**ISSUE-2**

**JINDAL ALUMINIUM LTD.**  
BANGALORE-560073 (INDIA)

NAME	DATE
DRAWN	J.P.KAUSHIK	08-07-2016
CHECKED		
APPROVED	S.S. GARG	13-08-2016
SCALE		2:1
AREA mm <sup>2</sup>		101.699
PERIMETER mm.		174.106
WEIGHT kg/m		0.275
DRAWING No.	SECTION No.	
P-14468-1	-	
S4419	S4419(ISSUE-2)	
34077	34077

S4419

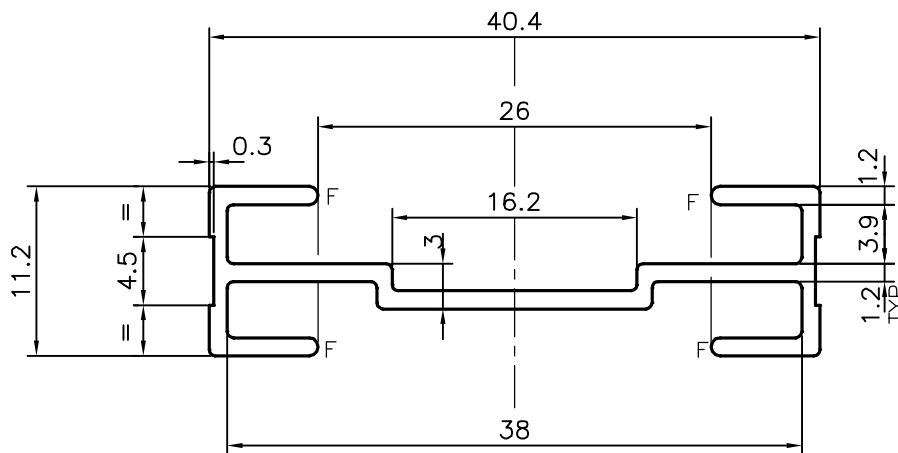
THICKNESS CHANGED FROM 1.0 TO 1.20 mm

DIMENSION CHANGED FROM 40 TO 40.4, &amp; FROM 10.8 TO 11.2 mm &amp;

OTHER DIMENSION CHANGE ACCORDINGLY.

WEIGHT ALSO CHANGED FROM 0.205 kg/m TO 0.275 kg/m
